Office Action Summary

10/713,788

REESE, KARL S.

DETAILED ACTION

FIG. 4

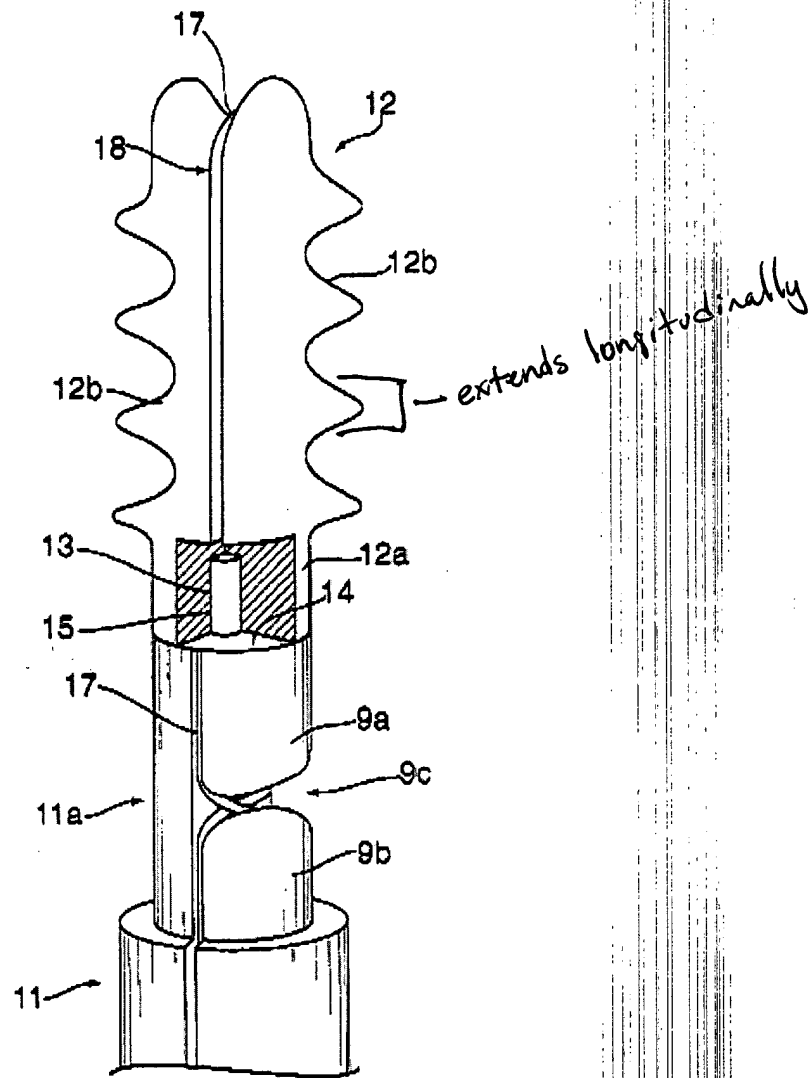
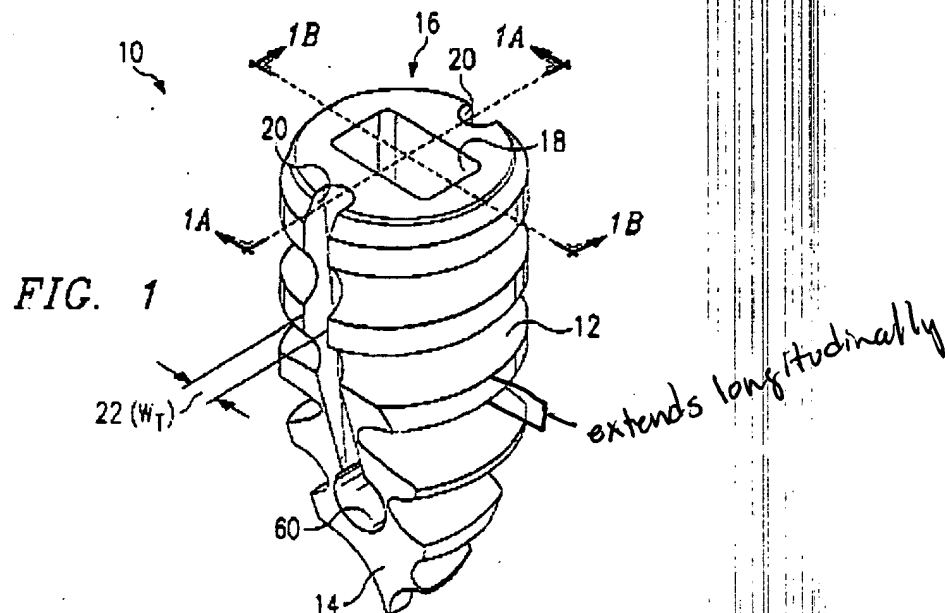
3. In response to the applicant's argument that Tormala does not disclose a suture anchor having longitudinally extending surface features. Tormala discloses barbs 12b that extend in at least some degree longitudinally. As stated before the degree of extension is not positively claimed. Tormala meets the claim limitation.

FIG. 4

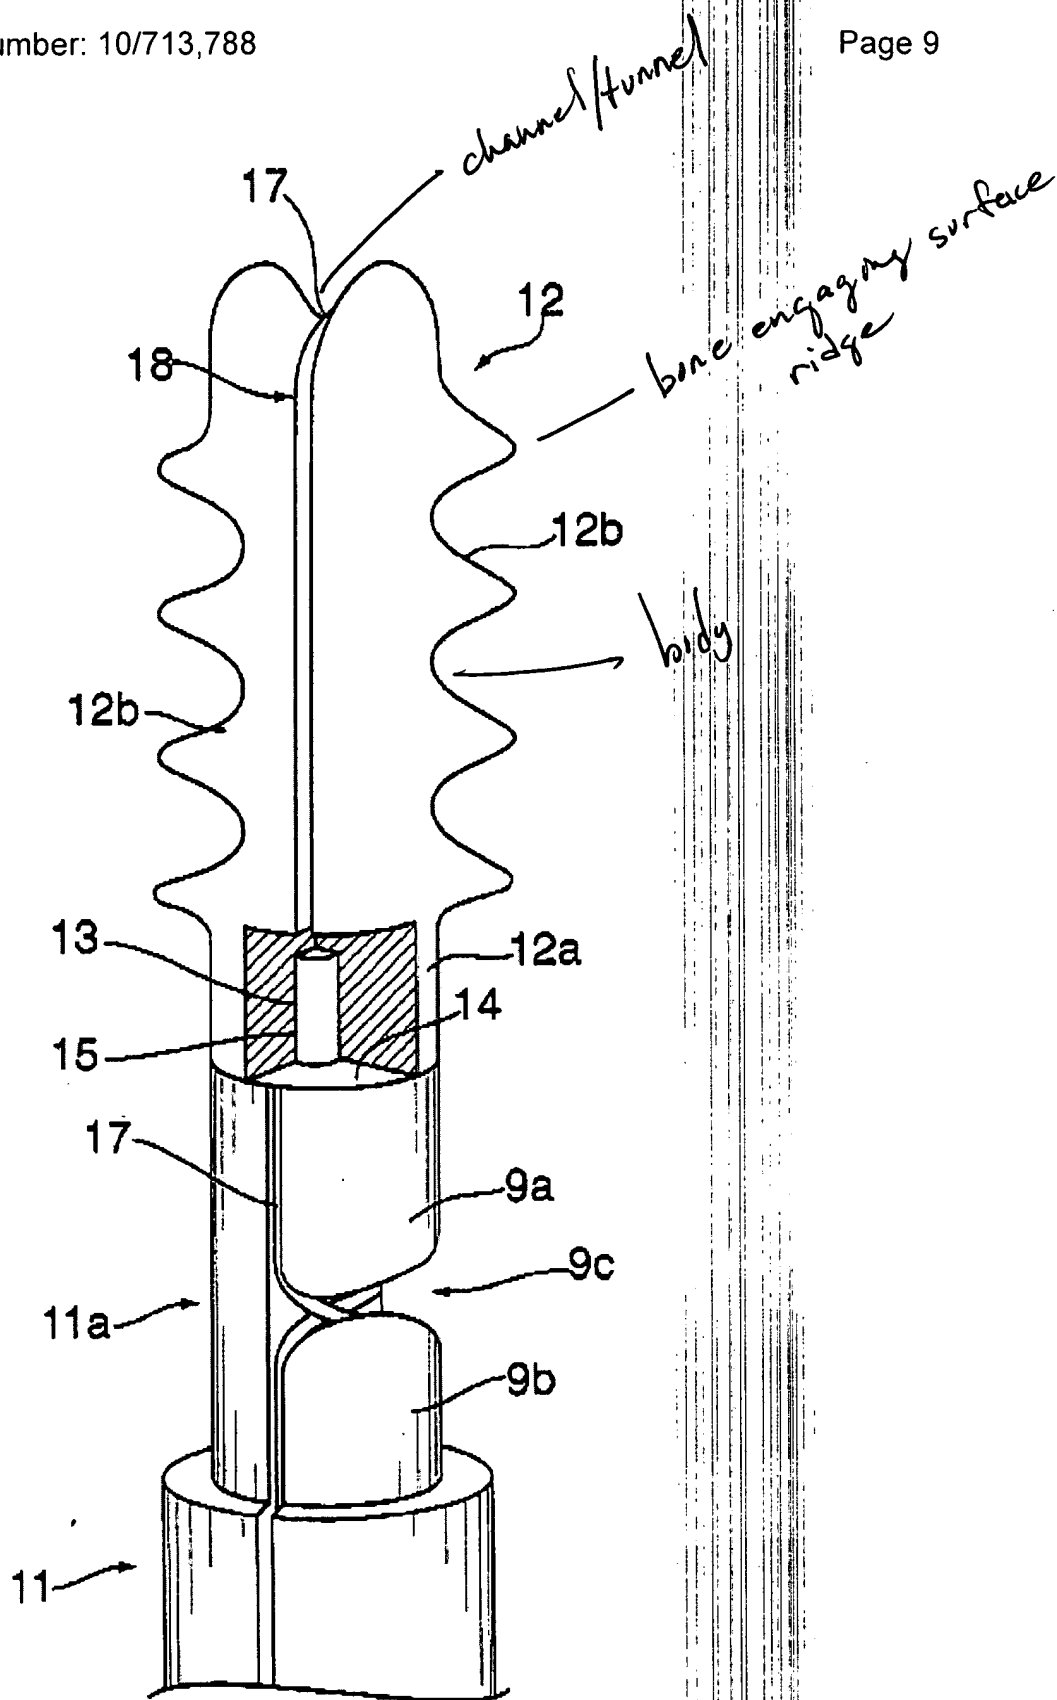
10. Tormala et al. teaches a suture anchor adapted to be disposed within bone, comprising: an elongate body having a proximal end, a distal end, and at least one discrete bone-engaging surface feature formed thereon and adapted to engage bone; a transversely-extending suture tunnel formed proximal to the distal end of the body such that the distal end of the body has a substantially solid distal tip; first and second

opposed suture-receiving channels formed in the body and extending from the proximal end of the body and terminating at the suture tunnel; and a suture loop disposed within the first and second opposed suture-receiving channels and the transversely-extending suture tunnel, the suture loop including a proximal portion positioned proximal of the proximal end of the body; wherein the first and second opposed suture-receiving channels are in communication with the suture tunnel; wherein the elongate body includes a plurality of discrete bone-engaging surface features formed thereon and adapted to engage bone; wherein the first and second opposed suture-receiving channels are adapted to seat the suture loop flush or sub-flush with an outer surface of the body; wherein the first and second opposed suture-receiving channels are fully capable of seating and engaging the suture loop, yet allow slidable movement of the suture loop; wherein the elongate body tapers from a proximal end to a distal end; and a driver-receiving element 4 formed in the proximal end of the elongate body.

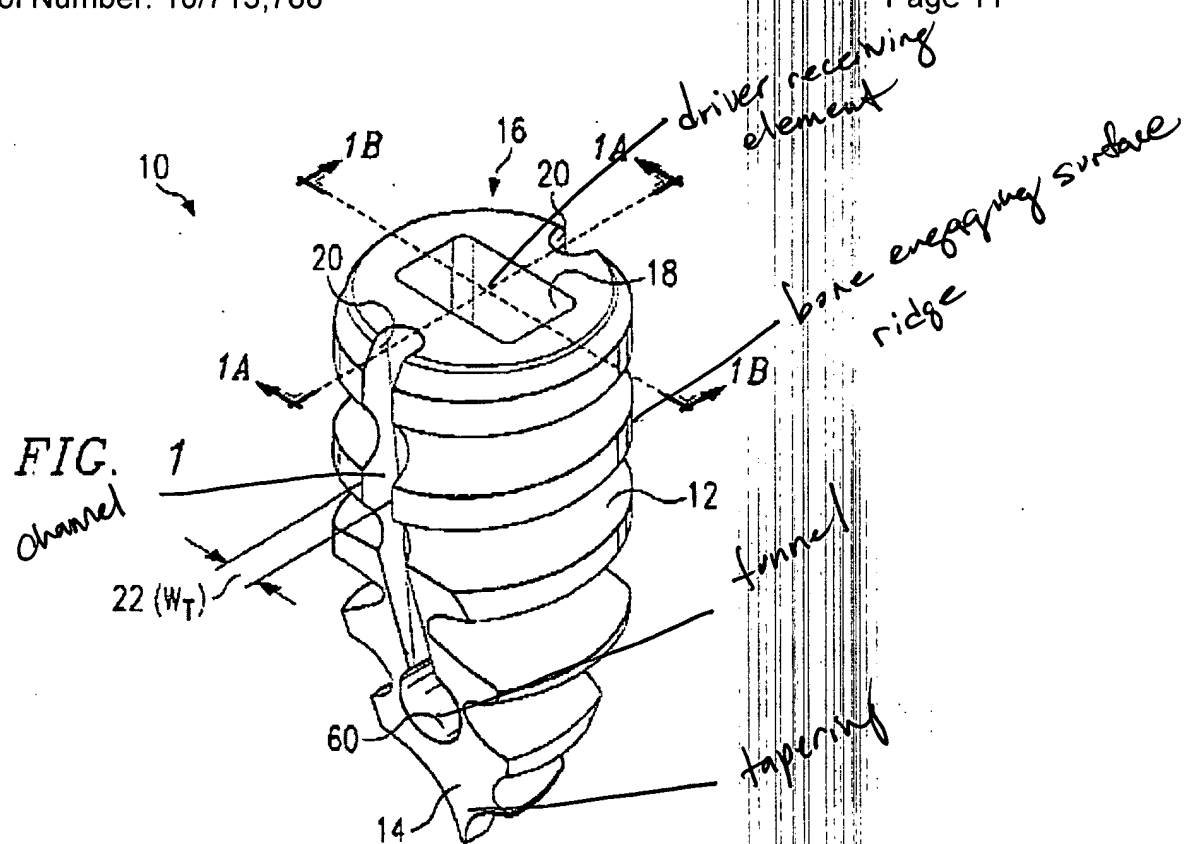
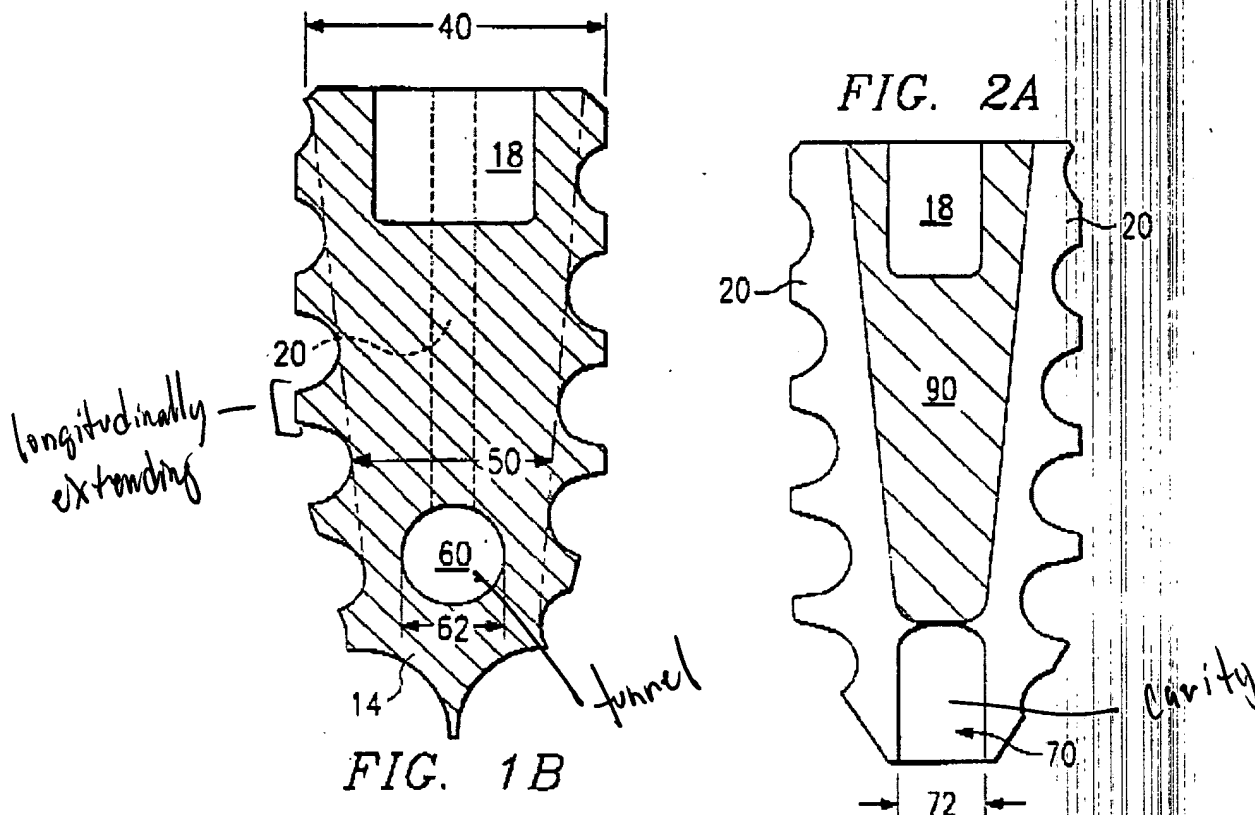
12. Dinsdale teaches a suture anchor adapted to be disposed within bone comprising: an elongate body having a proximal end, a distal end, and at least one discrete bone-engaging surface feature formed thereon and adapted to engage bone; a transversely-extending suture tunnel formed proximal to the distal end of the body such that the distal end of the body has a substantially solid distal tip; first and second opposed suture-receiving channels formed in the body and extending from the proximal end of the body and terminating at the suture tunnel; and a suture loop disposed within the first and second opposed suture-receiving channels and the transversely-extending suture tunnel, the suture loop including a proximal portion positioned proximal of the proximal end of the body; wherein the first and second opposed suture-receiving channels are in communication with the suture tunnel; wherein the elongate body includes a plurality of discrete bone-engaging surface features formed thereon and adapted to engage bone; wherein the suture loop includes a knot that is positioned within the transversely-extending suture tunnel (col. 4, lines 20-41); wherein the first and second opposed suture-receiving channels are adapted to seat the suture loop flush or sub-flush with an outer surface of the body; wherein the first and second opposed suture-receiving channels are fully capable of seating and engaging the suture loop, yet allow slidable movement of the suture loop; wherein the elongate body tapers from a proximal end to a distal end; and a driver-receiving element 18 formed in the proximal end of the elongate body.
